Service Bulletin

Bulletin No.: 19-NA-080

Subject: Information on Positive Crankcase Ventilation (PCV) Drain Tube Deletion

5314689

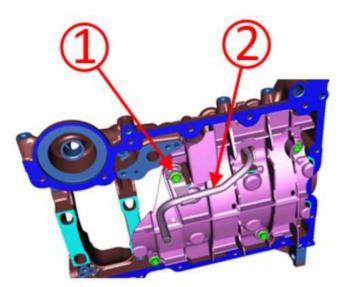
Involved Region or Country	United States, Canada, Europe, Russia, Middle East, Israel, Palestine, Argentina, Brazil, Chile, Colombia, Ecuador, Paraguay, Peru, Uruguay, GM Korea Company, Thailand, Egypt, Other Africa		
	Some technicians may find the PCV drain tube installed during an engine repair.		
Condition	⇒ General Motors has determined that the PCV drain tube is not needed and it will be deleted mid-year 2019 and forward. Please be advised you will no longer see this tube when doing an engine service on these engines.		
Information	If the PCV drain tube on any SGE engine needs to be replaced, the tube is no longer available and replacement of the tube is no longer required.		
Information	⇒ Discard the old tube and replace the drain tube bolt with a shorter bolt to retain the crankcase oil deflector.

Note: It is very important that you use the shorter bolt if you discard the PCV drain tube.

1. Remove the bolt (1) that secures the PCV drain tube (2) to the crankshaft deflector and bedplate.

Note: The crankshaft deflector does not need to be removed.

- 2. Using care, remove the PCV drain tube assembly from the bedplate and discard.
- 3. Install the new shorter bolt.

Tighten the bolt to 15 N • m (11 lb ft).
